ADDENDUM

Addendum No:	02	Date:	4-8-2025
Project:	Butler County ESC Renovations	Project Number:	25120.00

M1.01 1/8" = 1'-0"

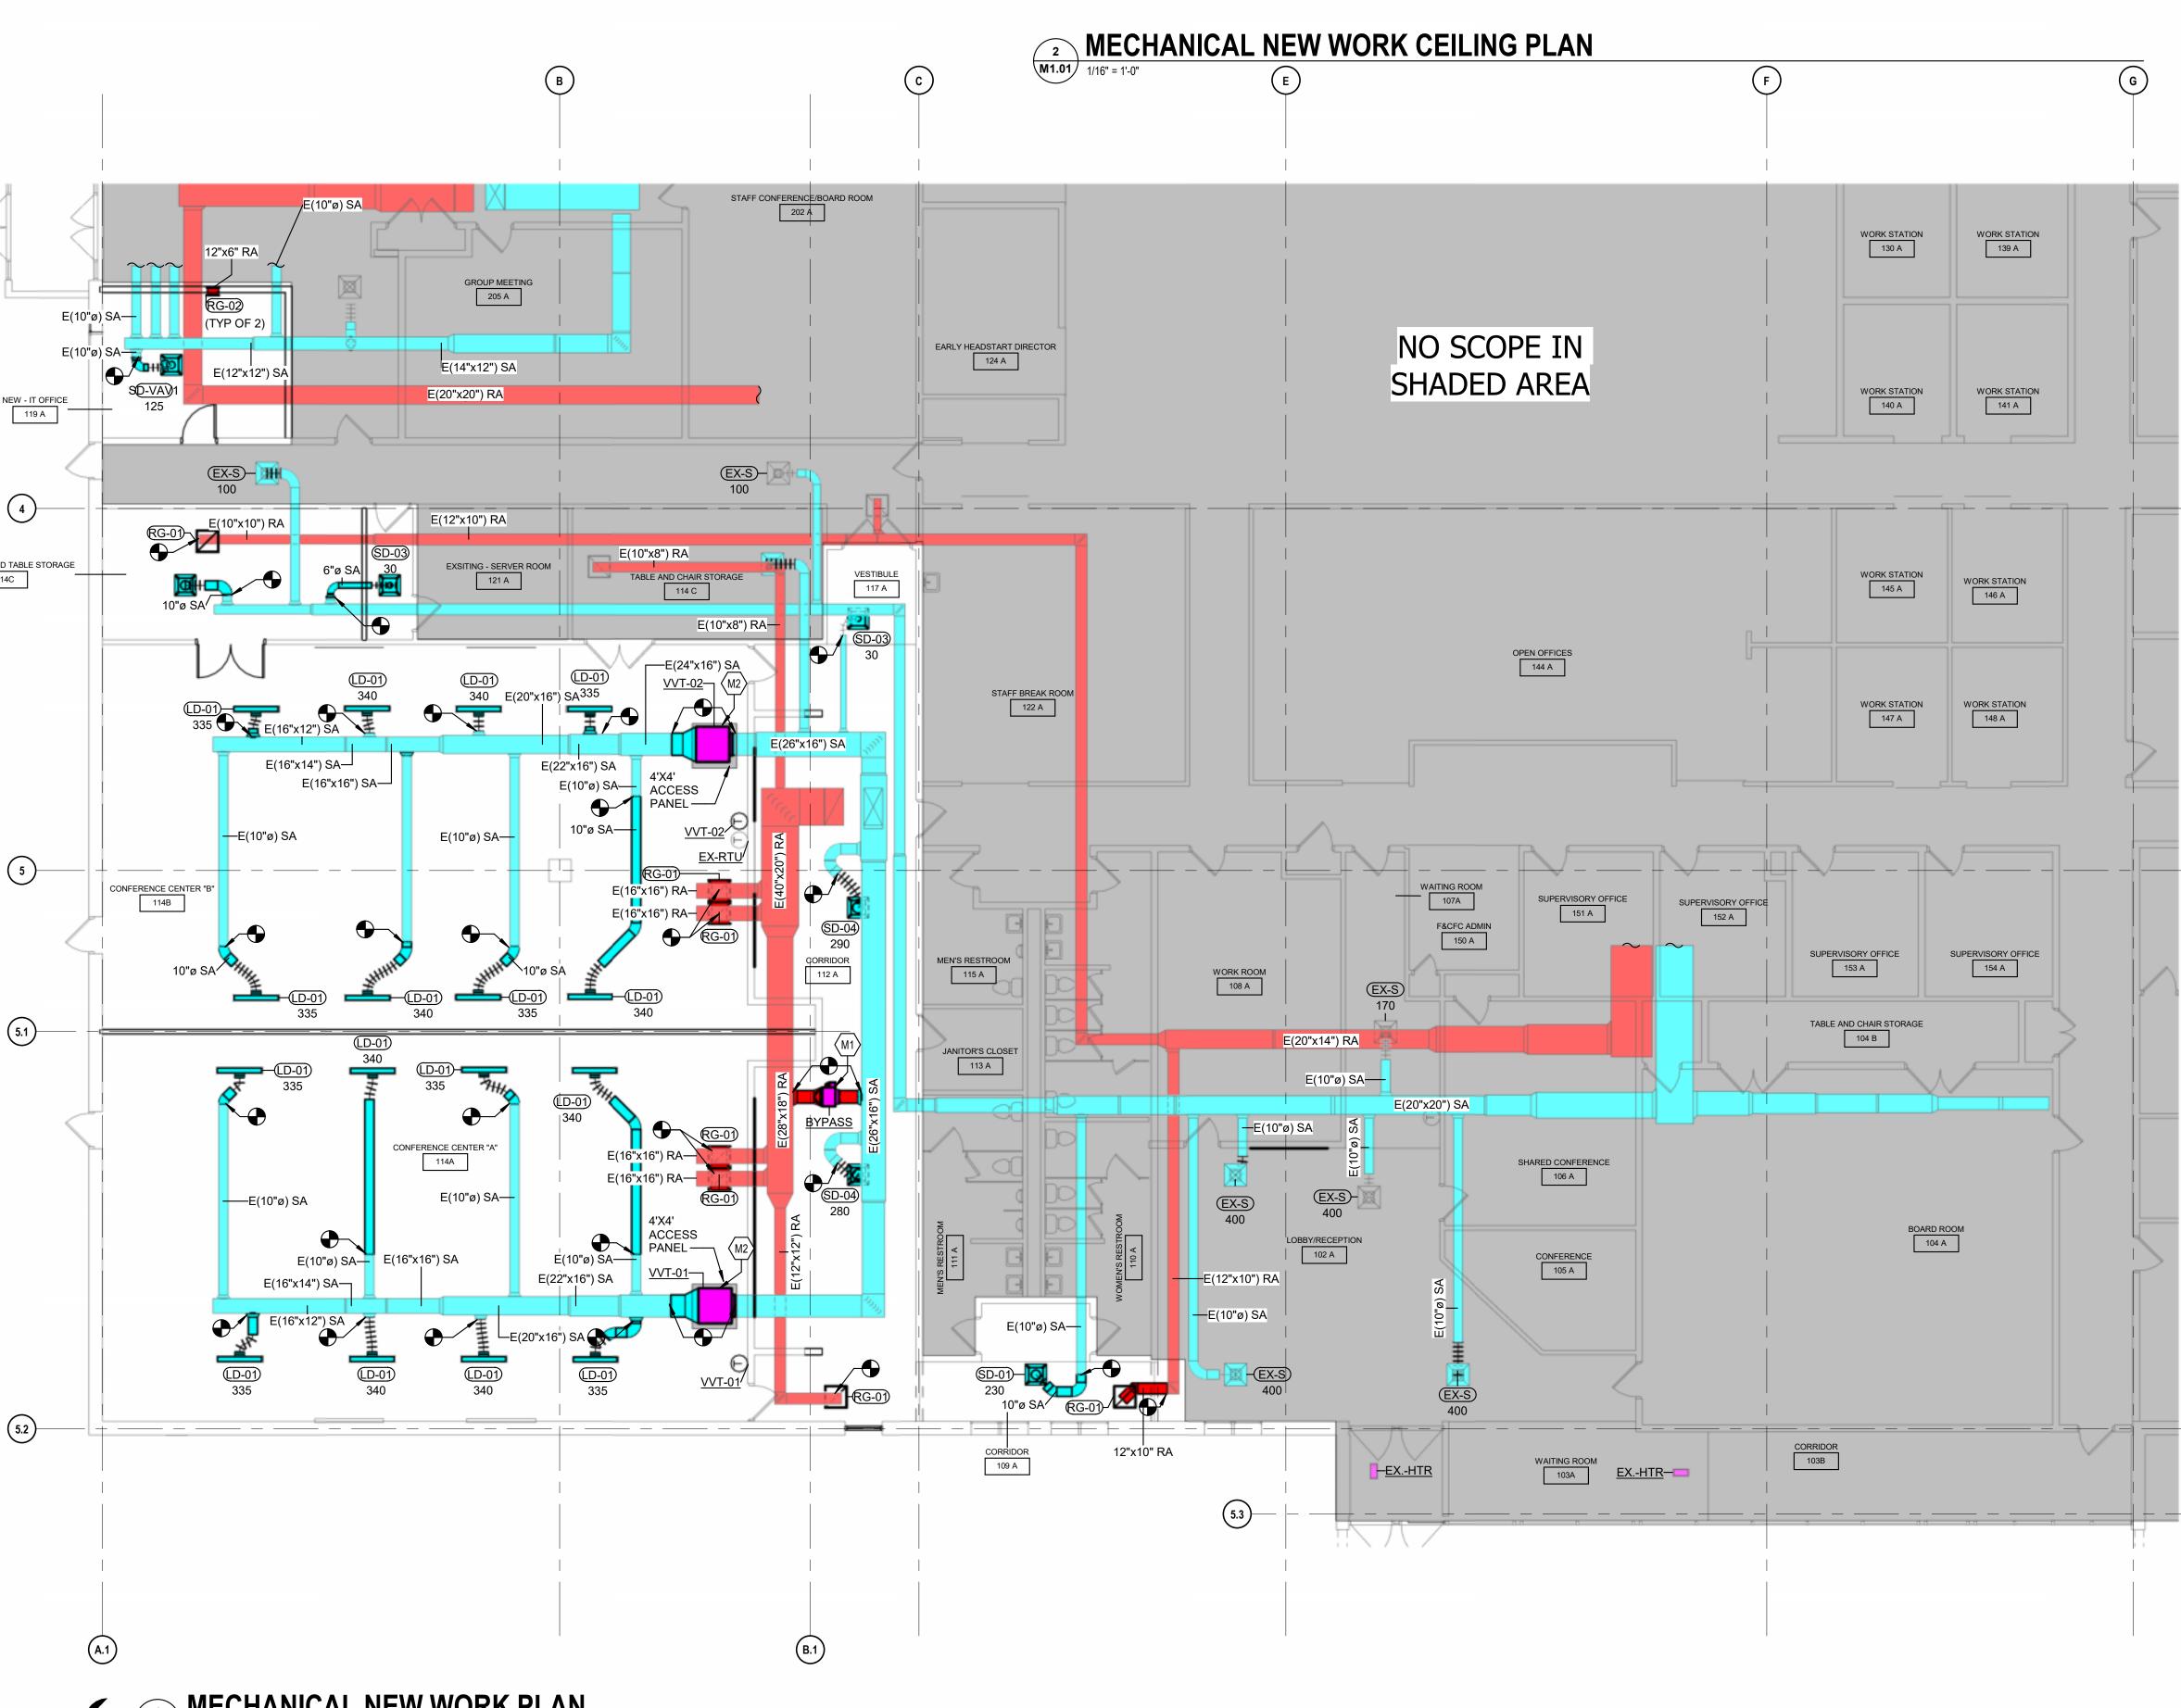
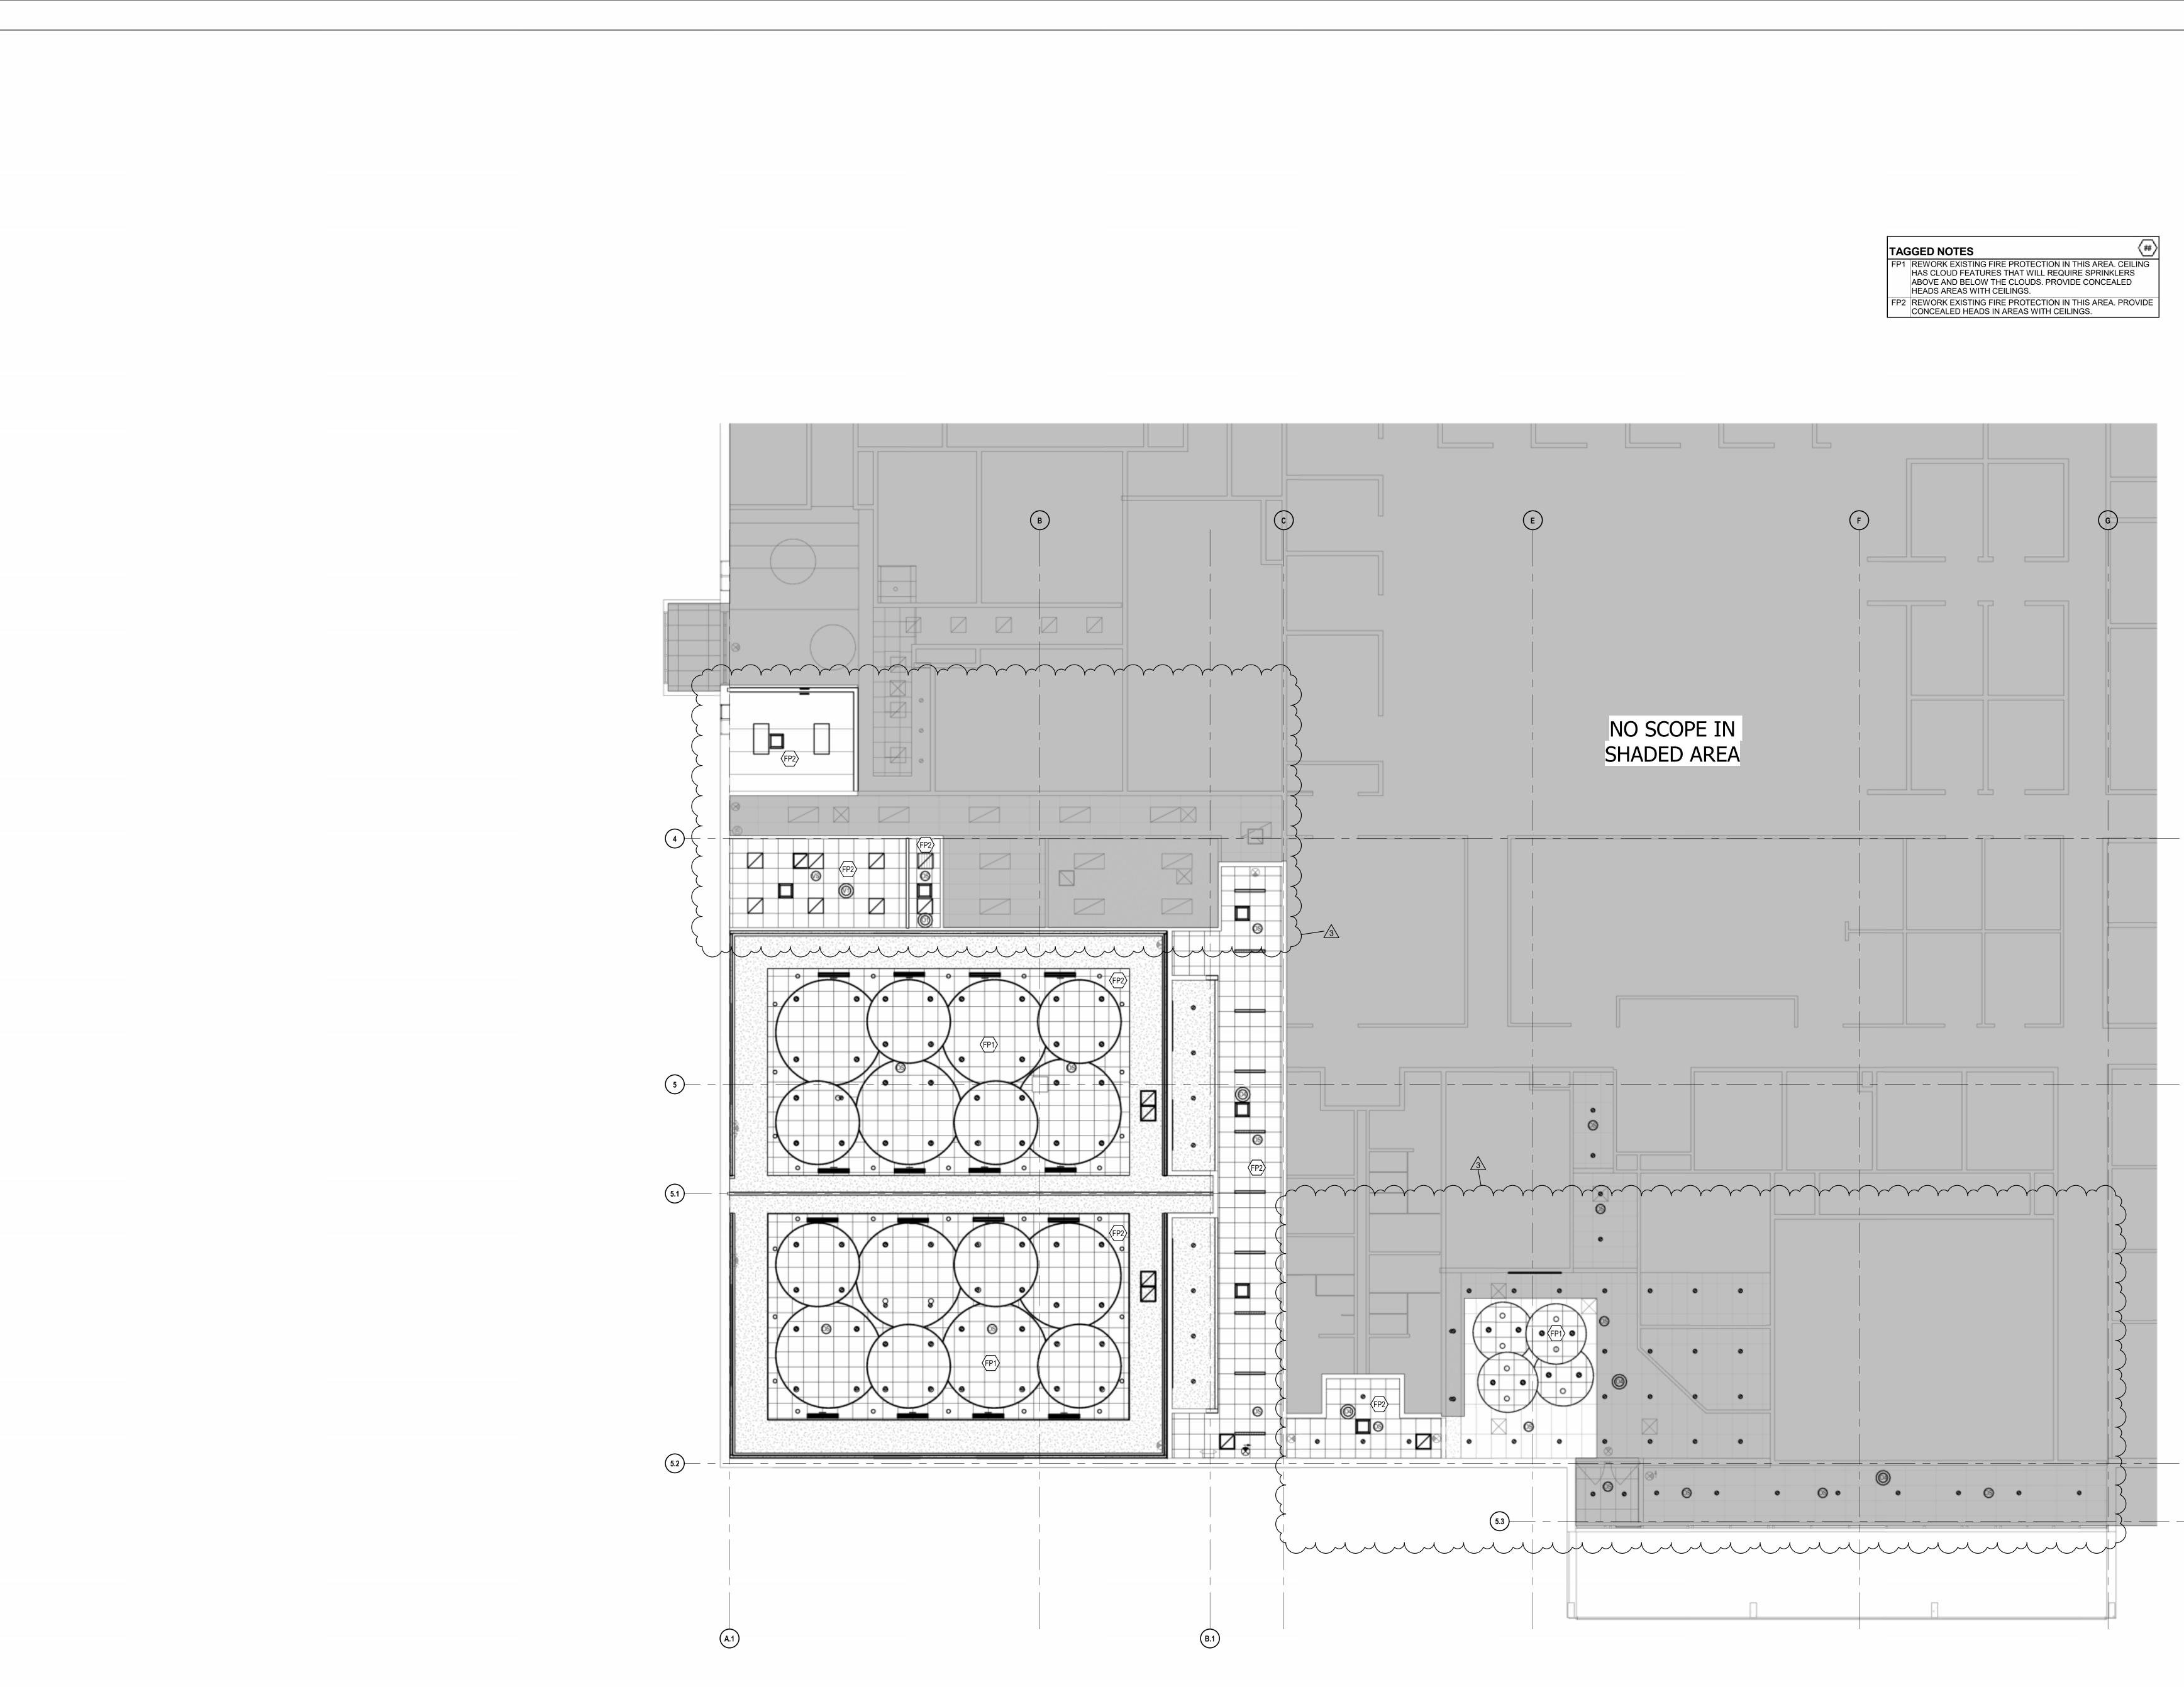
- 1.B Sheet: M1.00
 - a. Revised scope of HVAC work In main Lobby/Reception 102A, Waiting Room 107A, and Waiting Room 103A to maintain existing.
- 1.C Sheet: M1.01
 - a. Revised scope of HVAC work In main Lobby/Reception 102A, Waiting Room 107A, and Waiting Room 103A to maintain existing.
- 1.D Sheet: F1.00
 - a. Sheet is being reissued for clarity to align with plan and scope changes.
